# Public consultation comments and responses

## Cement Criteria

**Figure 1 Thermal energy efficiency and kiln capacity by kiln type**

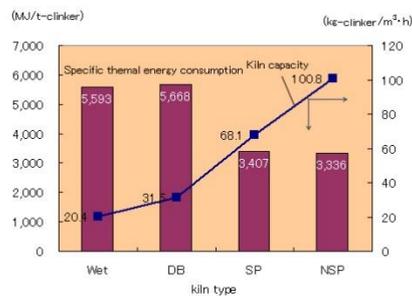
47 Chart 4 in Section 3.2.2 should be deleted for the following reasons since it is considered to provide an incorrect information.

1. There are few new facilities with an energy efficiency of 30% in cement plants. Though it is possible to provide substantial energy conservation using NSP or SP, such facilities have been already installed at the most cement plants. See the below figure 1.

Climate Bonds and the TWG agree that these proposed thresholds are overly ambitious and not reflective of available technological improvements. As such, decarbonisation measures are either:

- a) automatically eligible due to their mitigation benefit and lack of downside, or:
- b) eligible if part of a bundle of measures which achieve the same level of emissions reductions seen in the pathway for the period of the bond tenor

**Figure 2 Kiln capacity by the kiln type in Japan**

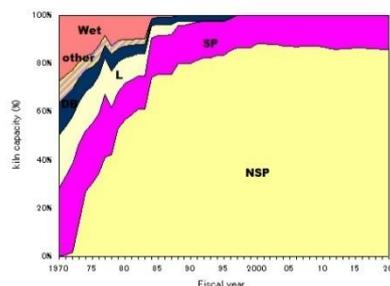
For instance, all kilns in Japan are composed of SP and NSP kilns. The transition is shown in Figure 2.

Therefore, the proposed mitigation criteria in Chapter 3.2.2 are inappropriate, because Japanese cement companies do not reduce CO2 emissions using substantial reduction equipment with more than 30%, but an accumulation of minor reduction measures

**Figure 3 Specific thermal energy consumption for cement production  
Kiln capacity by the kiln type in Japan**

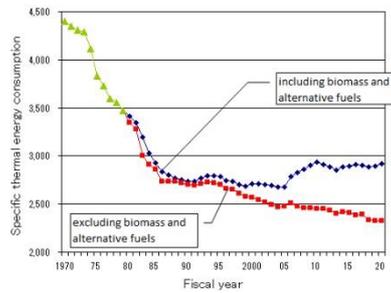
through operation management shown in Figure 3.

- An efficiency when installing multiple energy conservation facilities cannot be simply obtained by summing up all efficiencies since it may be offset between those of the facilities.
